Motor Vehicle Defect Petition to Recall All Tesla Vehicles Due to Sudden Unintended Acceleration

ODI — DP.23-002

Figure 1. The newer Model Y inverter board has no braking resistor.

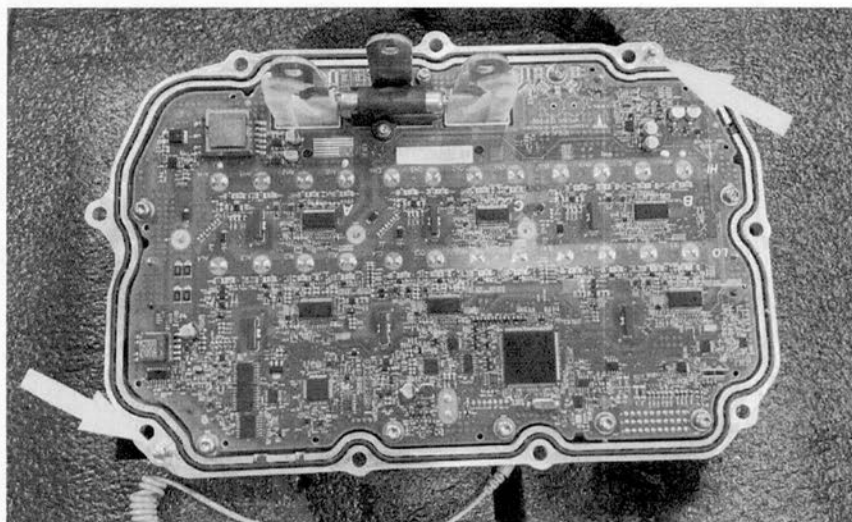
- 4) The new Tesla Model Y inverter board is shown in Figure 1. Notice that it does not have a braking resistor bank covered by a silicone heat spreader. This suggests that Tesla engineers may be aware of the fact that heat from the braking resistor can cause an increase in the junction temperature of TLF35584 PMIC

device, which is still used in this new design.^[Footnote 2] Tesla may claim that the braking resistor was removed for other reasons, such as reducing the board size. However, if this claim of board size reduction were valid, it would have been applied to the original Model 3 inverter board as well. But in that case the braking resistor was left on the board.
